PROJECT: Summerlin West Village @ 21 - Desert Foothills Drive - Update #1
(Red point Drive to Summerlin Parkway)

CITY OF LAS VEGAS		DATE:
INTER-OFFICE MEMORANDUM		September 8, 2020
TO: Land Development Services Department of Building & Safety		FROM: Albert Sung, P.E. Flood Control Project Engineer Department of Public Works
SUBJECT:	Drainage Study for:	
	Summerlin West Village 21 - Desert Foothills Drive – Update #1 (Redpoint Drive to Summerlin Parkway)	
Cross Streets:	Desert Foothills Dr. from Redpoint Drive to Summerlin Parkway	COPIES TO: VTN Nevada
File Number:	F:\Depot\DSMemos\DS5052F.doc	Howard Hughes Company, LLC
Parcel Number:	137-26-101-001	Bart Anderson, P.E., DevCo
Zoning Action:	N/A	CCRFCD
FEMA Flood Zone	YES	NO X
Proposed Storm Drain	YES X	NO

Update #1 to the Technical Drainage Study for

Summerlin West Village 21 Desert Foothills Drive (Redpoint to Summerlin Parkway)

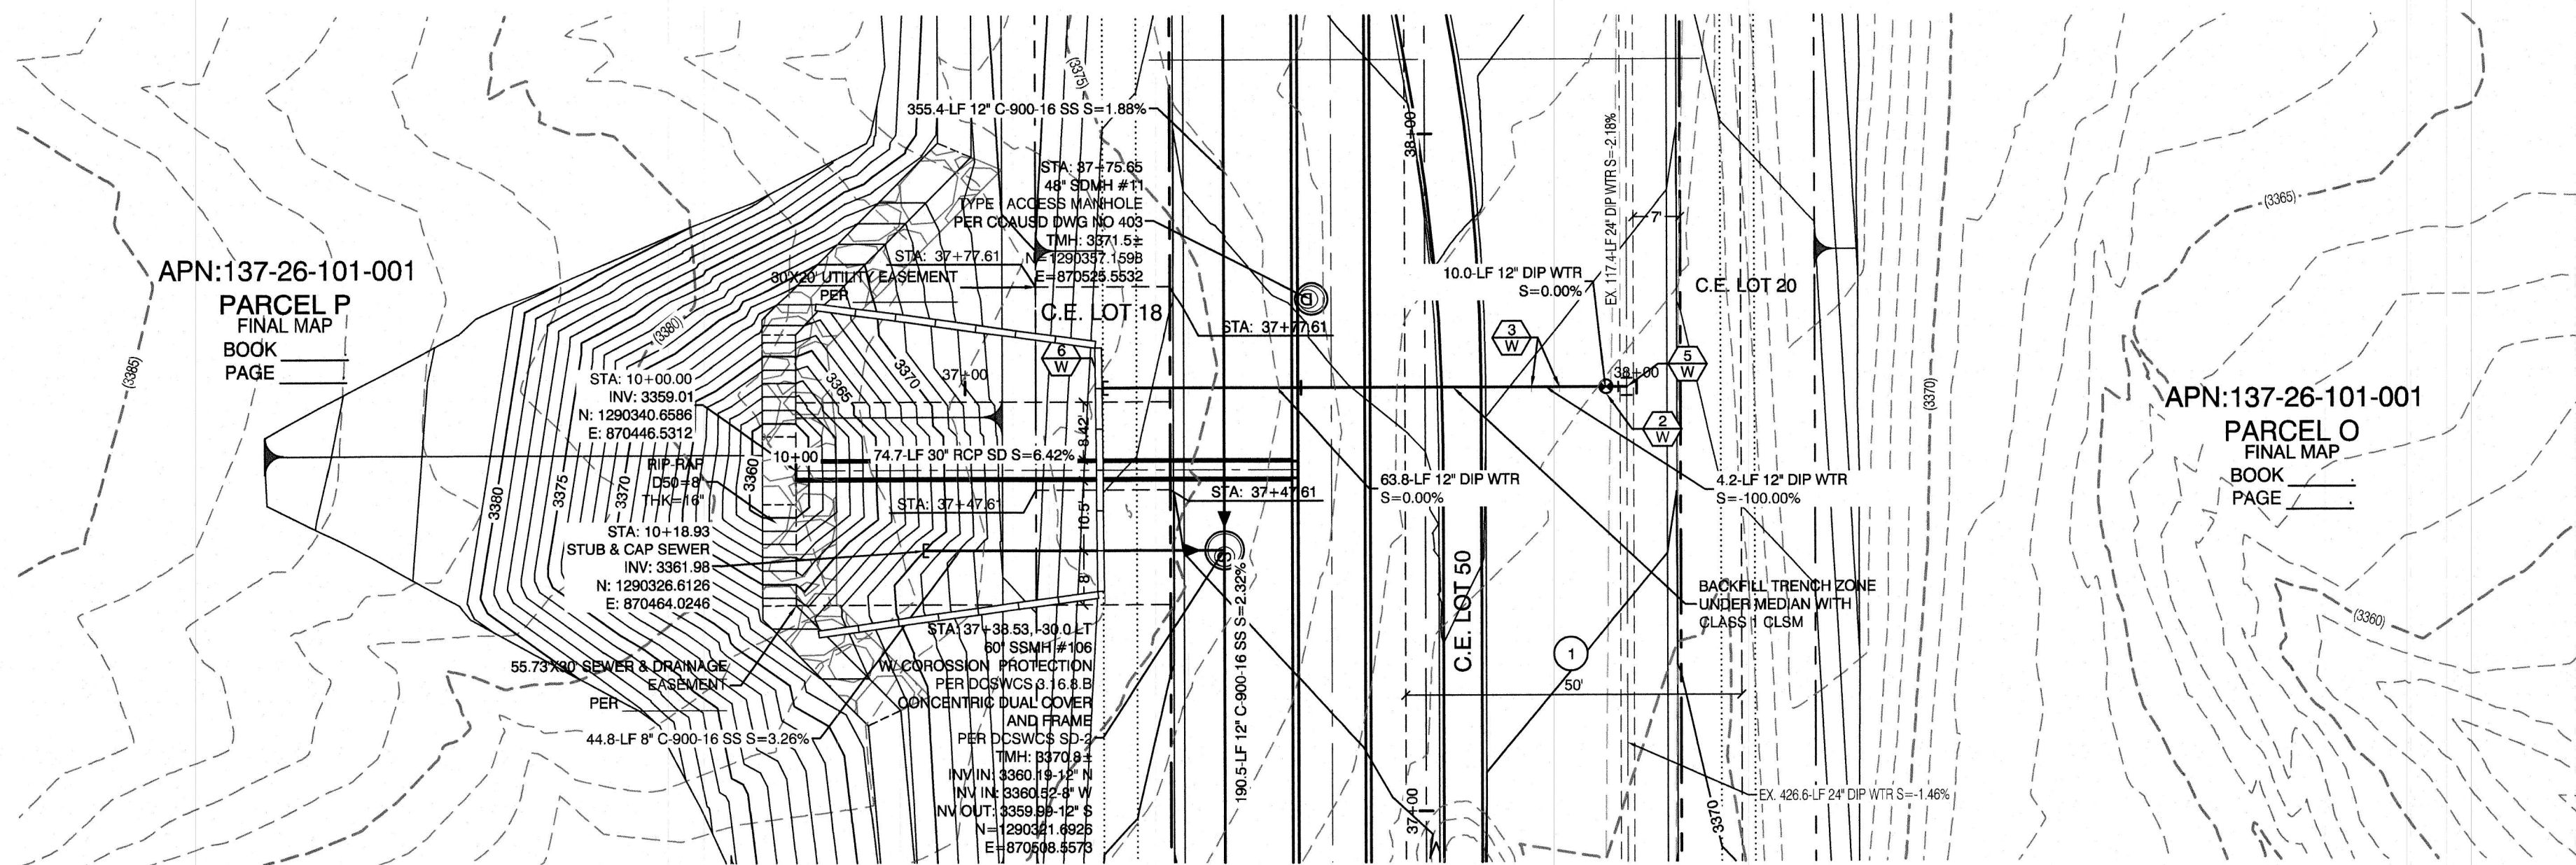
The SDMH#14 on Sheet UT5 has been moved approximately 29-feet south from Station 44+67.28 to Station 44+38.00. The alignment of the 10-ft by 8-ft RCB has not changed. This revision is being brought to the attention of City of Las Vegas Flood Control for documentation purposes. This revision does not impact the approved hydraulic models due to manhole losses having no hydraulic impacts to RCBs. Therefore, the approved WSPG model for the 10-foot by 8-foot RCB mainline does not require any revisions.
